**Addendum (Revision 2) to Remedial Action Options Report (RAOR)  
and Pre-Design Sampling Work Plan - Connell Aluminum Properties, LLC  
Former Koppers Tar Plant and Wabash Alloys Site  
9100 S. 5<sup>th</sup> Avenue, Oak Creek, WI 53154  
BRRTS# 02-41-553761, FID#241379050  
Connell VPLE BRRTS #:06-41-560068**

September 28, 2021

**City of Oak Creek Utility Corridor Lot 1  
9170 South 5<sup>th</sup> Avenue, Oak Creek, WI 53154  
BRRTS#: 02-41-561425, FID #:341074470  
VPLE BRRTS#: 06-41-561426**

PROJECT NO. 2095/6.1
FIGURE NO. C4

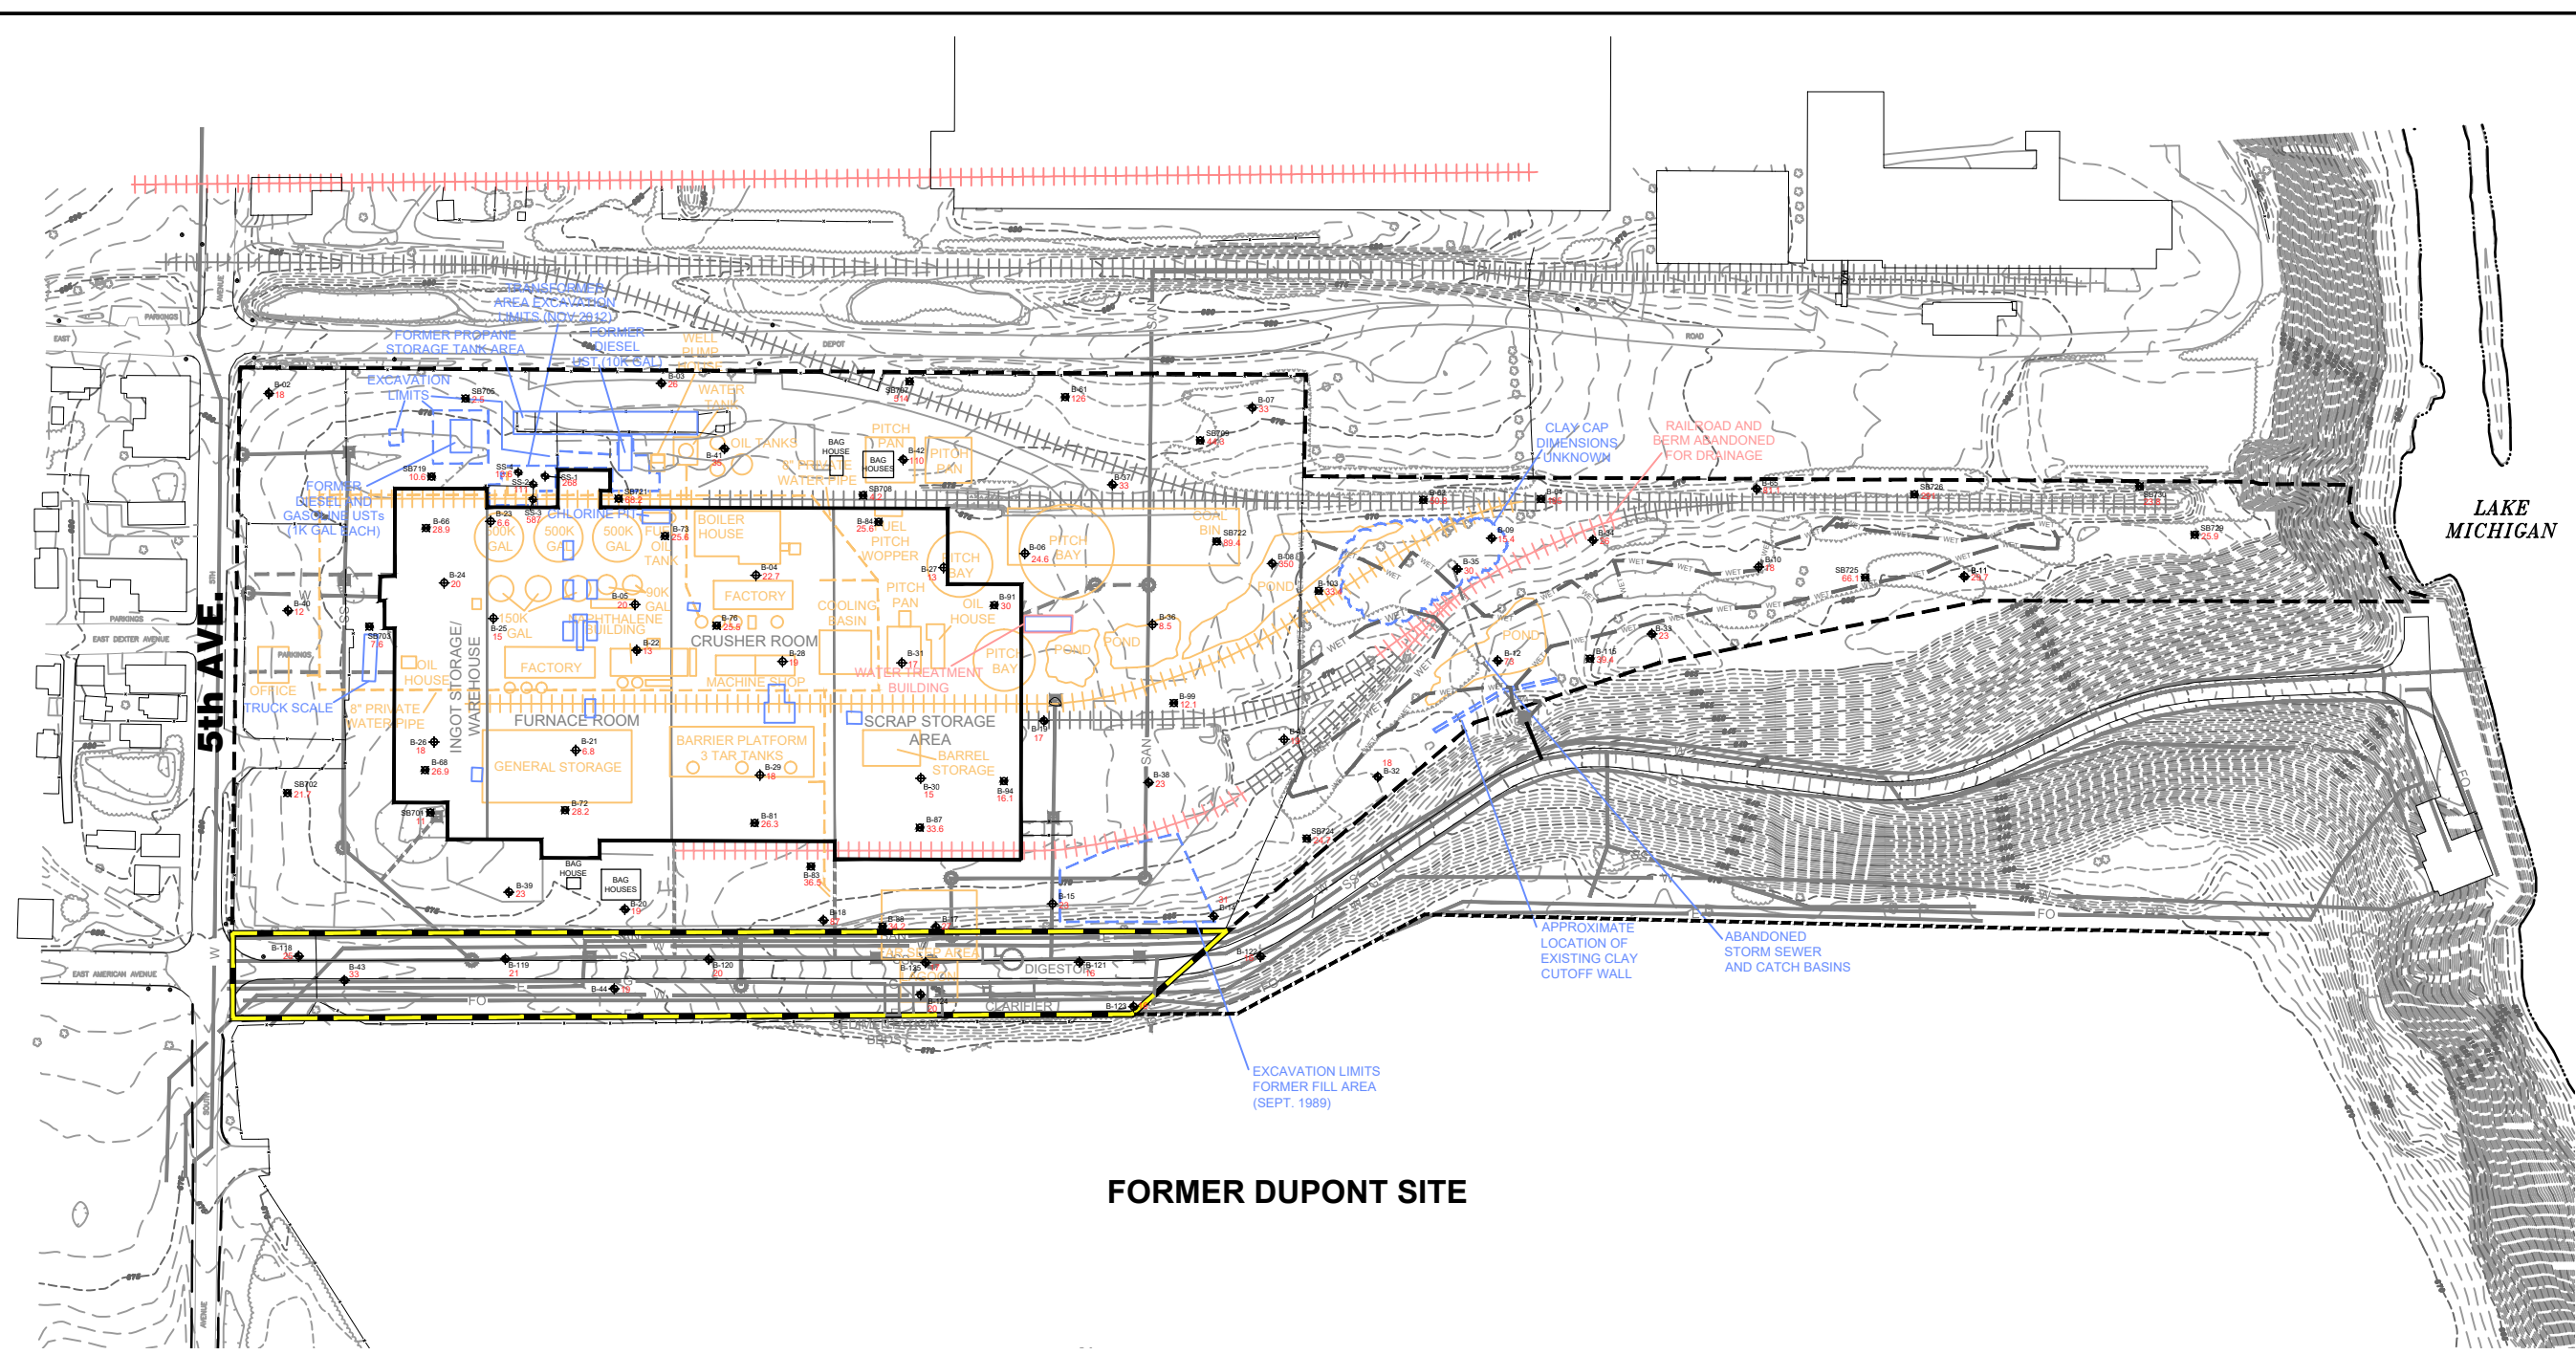
On January 27, 2014, NRT resubmitted the SI Report Figures C4 (Chromium, 0-4 ft bgs) and C8 (Silver, 0-4 ft bgs) after realizing an error on the figures that did not match the tables for chromium and silver (NRT transmittal dated January 27, 2014 is attached). Note that the data for B-08 has been corrected on these figures and are attached.

Eric – Attached are 3 hard copies of the revised figures and 3 full report CDs for the Site Investigation Report (VPLE BRRTS Activity #06-41-560068). As I mentioned over the phone, we made edits to Figures C4 and C8 and are providing updated versions. You may recycle the current Figures C4 and C8 and the CDs provided with each report. If you have any questions, please let me know.
